Access Compliance Report

Public Rights-of-Way

(Curb Ramps)

Intersection ID: 30508	Main Street: PLANTERS_ESTATES_DR	Cross Street: SUNRISE_VIEW_DR	Location: SE
ADA ID: 7B5C4275647B	Ramp Type: PerpDiag	Initial Pass/Fail: Fail	Overall Compliance: No
Severity Score: 22.5			
Codes/Mitigation Info/Possible Solution		Field Measurements/Component Compliance

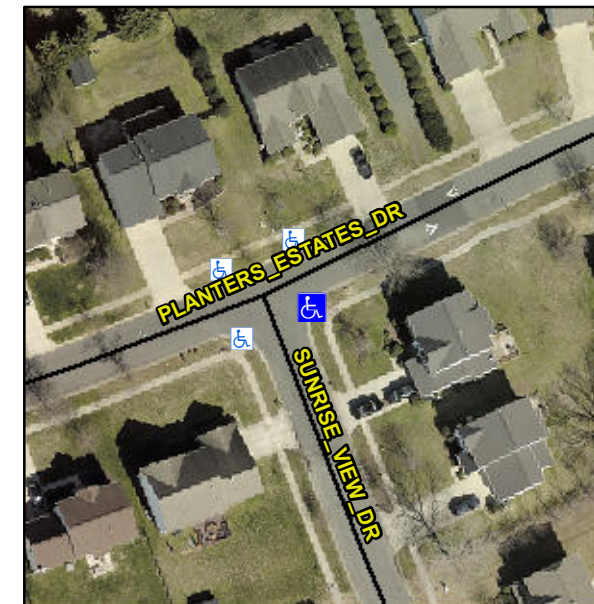
R304.5.1, R304.2.2, R304.5.3

Compliance	Description	Data	Compliance	Description	Data
N/A	Ramp Length (in)	44.0	No	Ramp Slope (%)	10.3
No	Ramp Width (in)	47.5	No	Ramp XSlope (%)	2.4
N/A	Flare Type LT	N/A	N/A	Flare Type RT	N/A
N/A	Flare Slope LT (%)	N/A	N/A	Flare Slope RT (%)	N/A
N/A	Flare Traversable LT?	N/A	N/A	Flare Traversable RT?	N/A
N/A	Landing Length (in)	N/A	N/A	DWS Provided?	N/A
N/A	Landing Width (in)	N/A	N/A	DWS Contrast?	N/A
N/A	Landing Slope (%)	N/A	N/A	DWS Length (in)	N/A
N/A	Landing X Slope (%)	N/A	N/A	DWS Full Width?	N/A
N/A	Landing Curb? (Y/N)	N/A	N/A	DWS Offset (in)	N/A
N/A	Shared Landing?	N/A			
N/A	Gutter Ponding?	N/A	N/A	Gutter Slope (%)	N/A
N/A	Gutter Lip Ht (in)	N/A	N/A	Gutter X Slope (%)	N/A
N/A	Painted X Walk1?	No	N/A	Painted X Walk2?	No
	X Walk 1 Direction	To NW		X Walk 2 Direction	To SW
N/A	X Walk 1 Width (in)	N/A	N/A	X Walk 2 Width (in)	N/A
	X Walk 1 Slope (%)	4.7		X Walk 2 Slope (%)	2.3
	X Walk 1 X Slope (%)	0.5		X Walk 2 X Slope (%)	3.6

Remove & Replace Curb Ramp With Two New Directional Ramps or Equivalent.
